Docket Number 50-346

Subject: Response to Request for Additional Information on Individual
Plant Examination Submittal, Davis-Besse Nuclear Power Station,
Unit 1 (TAC NO. M74402)

**RESPONSE TO REQUEST FOR ADDITIONAL INFORMATION
FOR THE IPE PROGRAM
DAVIS-BESSE NUCLEAR POWER STATION**

Figure 1-7. Event Tree for Sequences Initiated by a Small LOCA

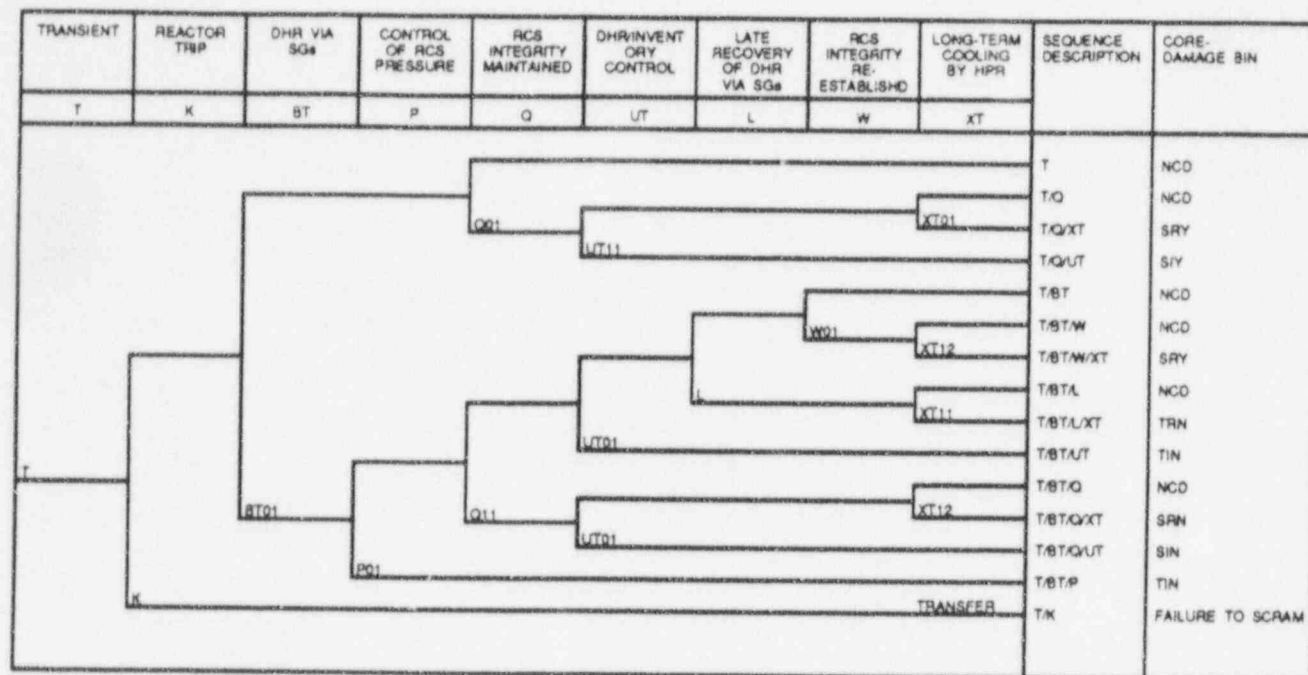
7. Please provide the small LOCA event tree which was not included in the IPE submittal.

Figure 5-9. Logic for Failure of CET Event C—Core Debris Fails to be Cooled Ex-Vessel (page 1 of 3)

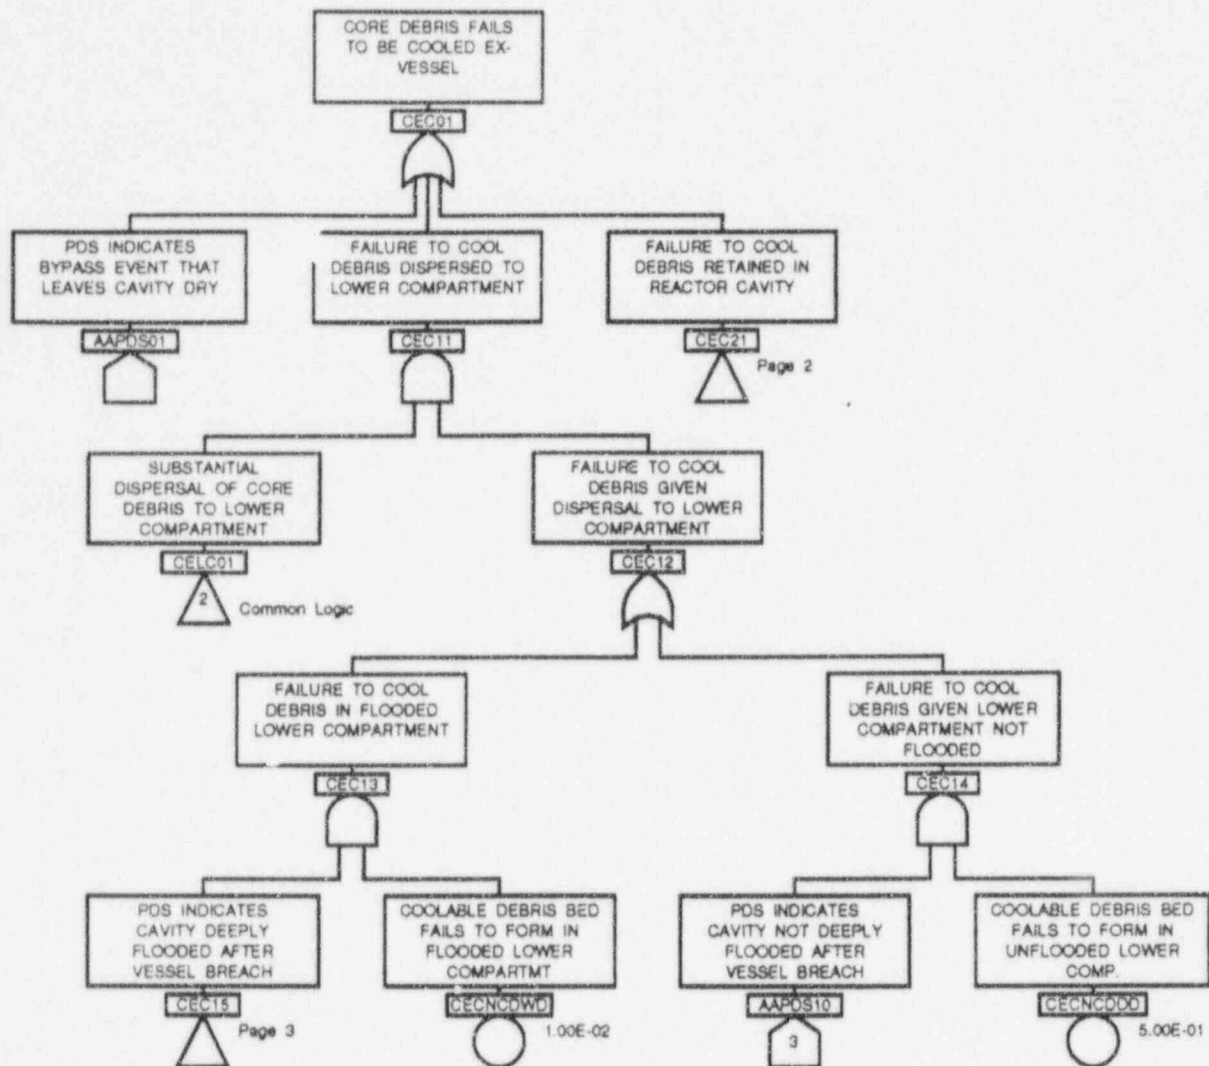
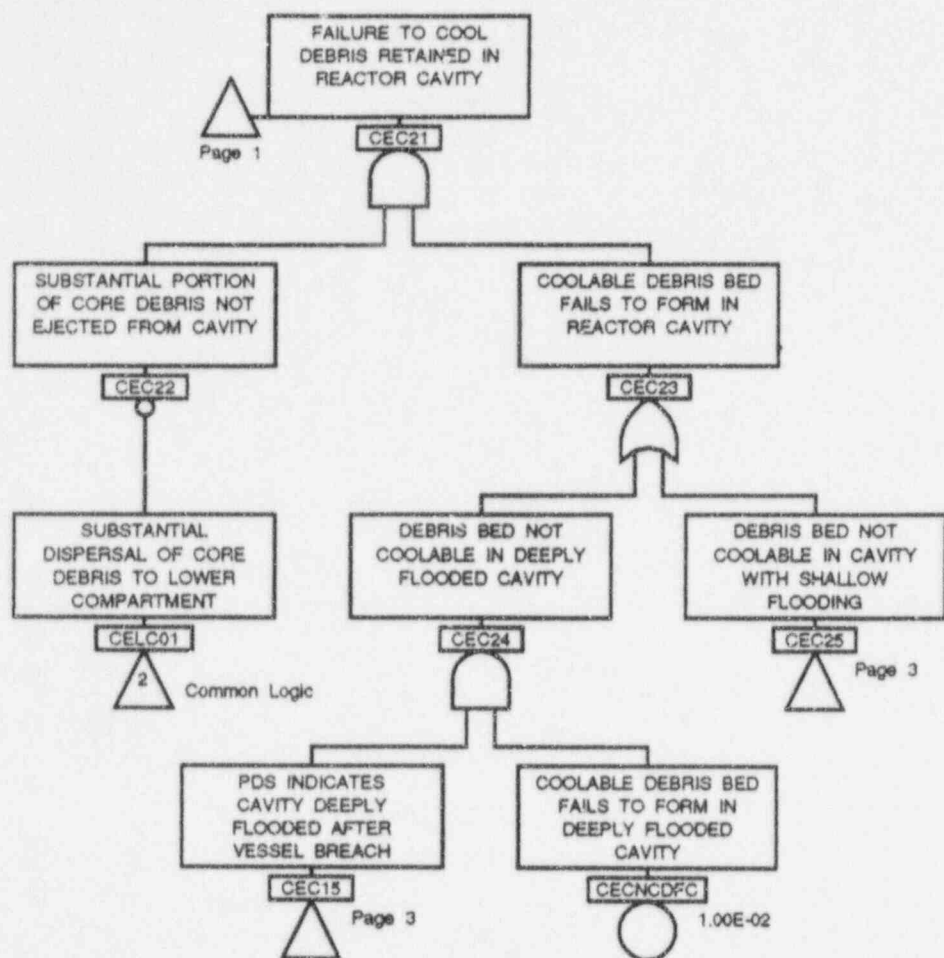
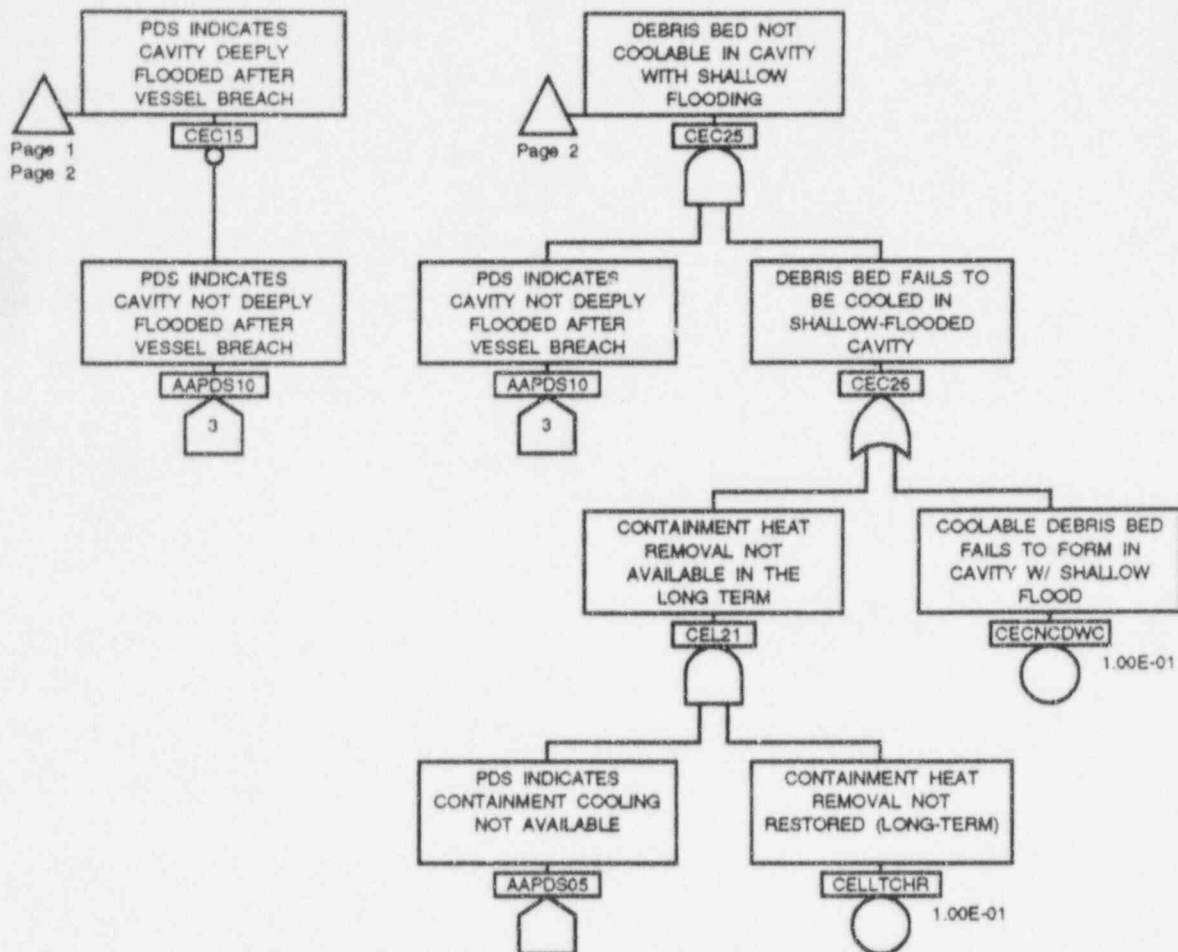
13. Davis-Besse uses a steel containment vessel and a reinforced concrete shield building, both of which are supported on a concrete foundation. The minimum basemat thickness is specified in Table 1-6 of IPE submittal Part 4 as 5.7 ft. This seems to be the thickness between the bottom of the normal containment sump and the base of the containment shield building. The thickness between the bottom of the sump and the containment steel shell appears to be significantly smaller. Please provide this thickness. Please explain how this (apparently) rather thin concrete layer was treated in your evaluation of the probability of basemat melt-through. Presumably, once the steel shell is penetrated, some release will occur even if the shield building foundation has not been completely penetrated. The discussion should address the possibility that a large coherent mass released from the RPV may stay in a clump, spread slowly, and produce a large amount of localized core concrete interaction (CCI). Please also describe how your evaluation of

the probability of a coolable debris forming in the reactor cavity took this kind of scenario into consideration. Figures 1-12 and 1-14 show other locations where the distance from the cavity floor to the steel shell appears to be small, e.g., at the first bend of the incore instrumentation tunnel. How were these other areas considered in your evaluation of basemat melt-through? If they were not considered, please justify their omission.

The precise location of a potential melt-through of the containment basemat was not critical to evaluating the possibility for this occurrence in the containment event tree. As discussed in Part 4 Section 5.2.6 and associated Figure 5-9 (see Attachment 4), core debris in the cavity region is assumed to result in basemat failure if a coolable debris bed is not formed. The different weighting factors for the associated logic are primarily dependent on the degree of cavity flooding. While the potential depth of the corium was a factor taken into consideration when assigning the respective weighting factors, the exact location was not considered to be a primary consideration (i.e., if the debris is not coolable, whatever depth of concrete is present will eventually be penetrated by ablation).
